DEVELOPMENT APPLICATION ASSESSMENT REPORT

Application Number:	DA2025/0013
----------------------------	-------------

Responsible Officer:	Anaiis Sarkissian
Land to be developed (Address):	Lot 102 DP 27580, 8 Bilambee Avenue BILGOLA PLATEAU NSW 2107
Proposed Development:	Alterations and additions to a dwelling house
Zoning:	C4 Environmental Living
Development Permissible:	Yes
Existing Use Rights:	No
Consent Authority:	Northern Beaches Council
Land and Environment Court Action:	No
Applicant:	Spannenberg & Son Pty Ltd

Figure 1: Shadow Diagram 9am June 21st

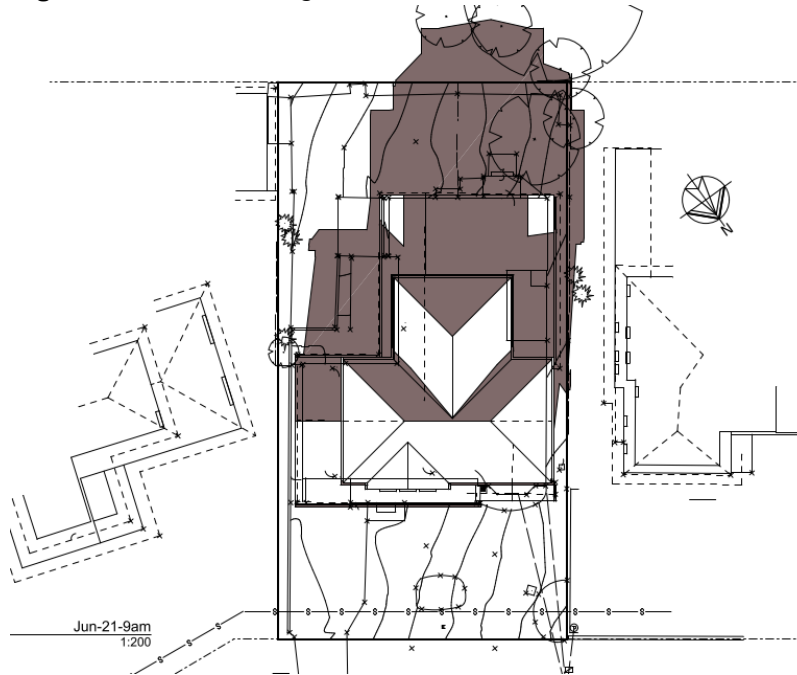
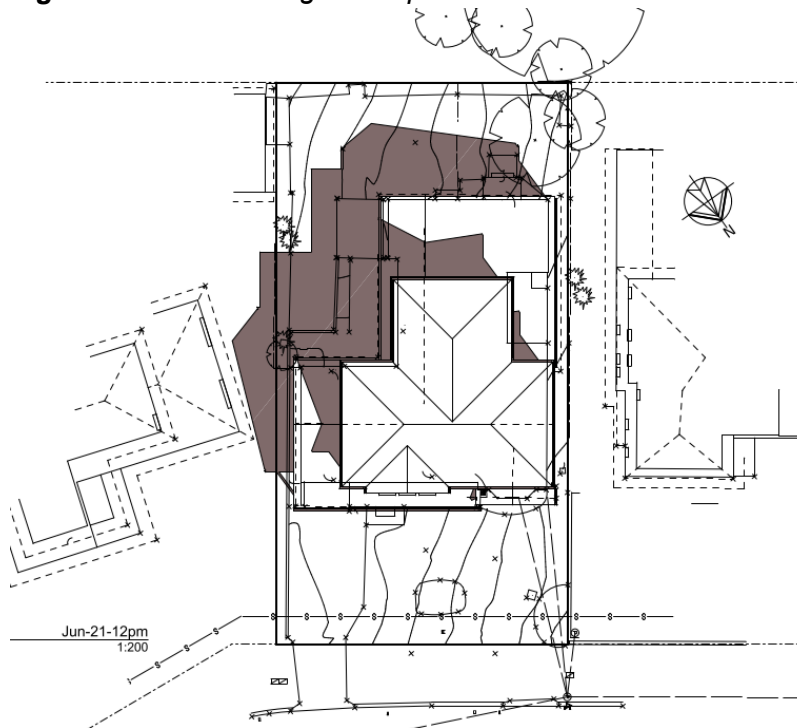
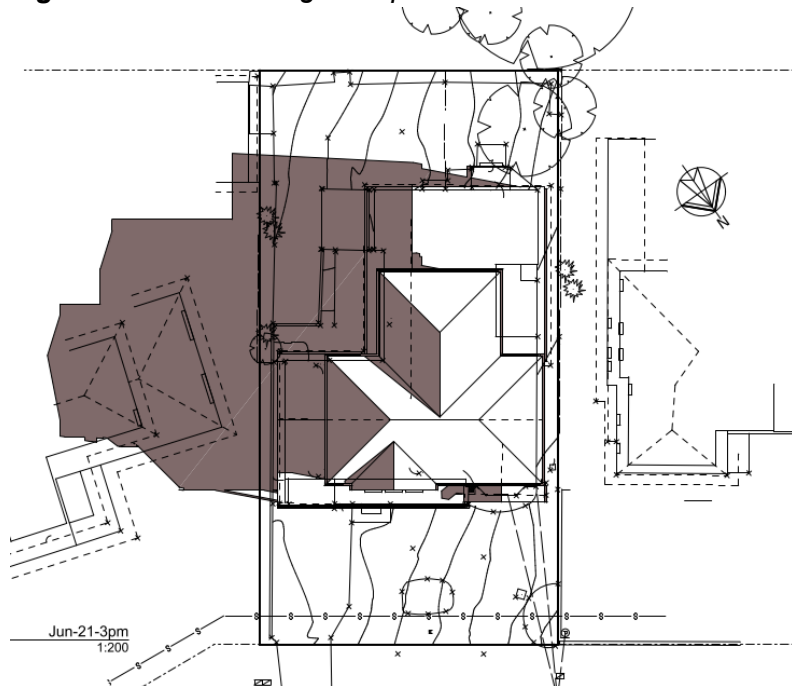
The submission noted that the proposal should consider any potential impacts to the adjacent reserve (Plateau Park), such as additional overshadowing or altered hydrology.

The proposal does not increase the existing development footprint or the amount of hardscaped area across the site. The submitted shadow diagrams demonstrate that only a small portion of the reserve will be overshadowed in the morning during Winter, as evident in Figures 1-3 below.

Figure 2: NW Elevation

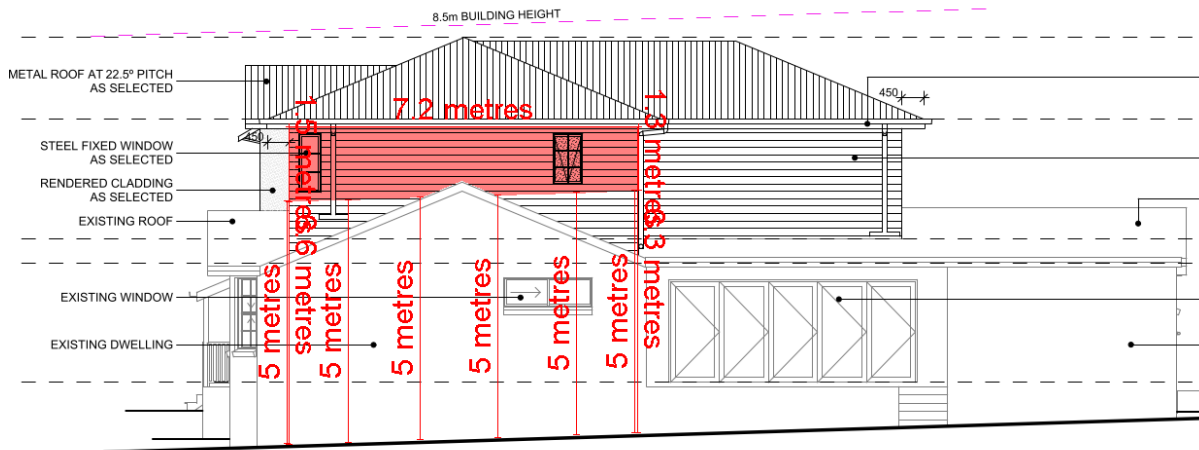
The north-western elevation presents an encroachment of between 1.3m and 1.5m in vertical height for a horizontal length of 7.2m, resulting in a maximum variation of 30% (1.5m), as shown shaded red in Figure 2 below.

It is important to note that this envelope breach is due to the existing raised ground floor level at this portion of the site given the sloping topography of the land, as evident in Figure 3 below. There is also 500mm spacing between the finished ground floor ceiling level and the finished first floor level. It is also important to note that this envelope breach is not associated with the entire north-western elevation due to larger setbacks from the north-western boundary. Additionally, there are only two small windows proposed at this elevation at the first floor; one window is an obscure awning bathroom window, and the other is a very narrow bedroom window, which is a low-activity room. Furthermore, the north-western elevation is set back a compliant 1.5m from the north-western boundary, and the aspect of this elevation means that there are no shadows cast to the north-western neighbour. The footprint of the first floor level is also modest in size.
